**September 04, 2025****Addendum No. 06****File Reference Number: RFP 2025 068****Title: ONTC Culvert Rehabilitation – Culvert Mile 109.8 Kapuskasing Subdivision****RE: Clarifications/Questions**

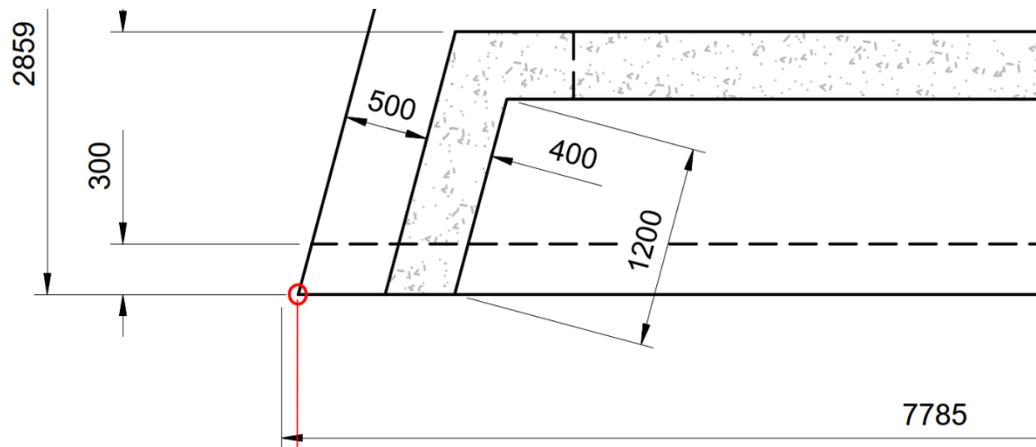
**Item 1:** In drawing S-04, the plan shows the footing length as 7785mm. Is this length correct?**Answer:** The dimension is mistakenly taken from the end of another dimension line and not the intended corner as shown in the image below:

The correct dimension is 7685mm, corresponding to the 15-degree angle shown on the PLAN.
